Verdin iMX8M Plus

Errata Document

Figure 1 Location of C210 (Bottom Side)

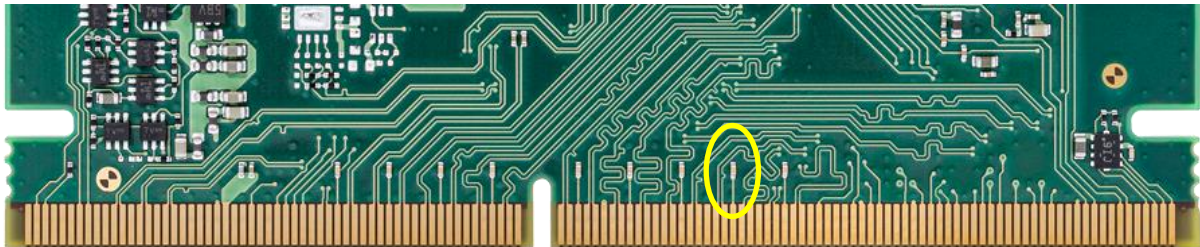
The Bluetooth solution is not accessible by the system as the host interface strapping signal of the Bluetooth solution is unintentionally influenced by a stitching capacitor on the SoM. This leaves the Bluetooth solution in the UART interface mode instead of SDIO.

The signal used for strapping the HCI (Host Controller Interface) configuration of the Bluetooth solution at the time of powering up the SoM is also available on the Module-specific pin MSP_8 (#104) of the SoM edge connector. Module-specific pins feature stitching capacitors for providing current return paths for cases when those pins are being used for accommodating high-speed signals.

The Verdin iMX8M Plus V1.0B configurations equipped with a Wi-Fi/Bluetooth solution feature one such capacitor (C210) on the MSP_8 signal. During powering up the system, the stitching capacitor delays the transition of the related signal to the intended state and thus results in a wrong configuration being strapped. Instead of SDIO mode, the host interface of the Bluetooth solution gets configured to UART mode. As a result, the Bluetooth solution is not accessible by the system.

Remove the stitching capacitor C210 from the SoM. This makes the Bluetooth interface work in case the SoM is connected to a Dahlia V1.1A carrier board.

If the SoM is connected to a Verdin Development Board V1.1A, then other stitching capacitors need to be removed from the carrier board as well. The issue will be resolved in future HW versions of these products. Please refer to HAR-8342 in the Verdin Development Board errata for more information.
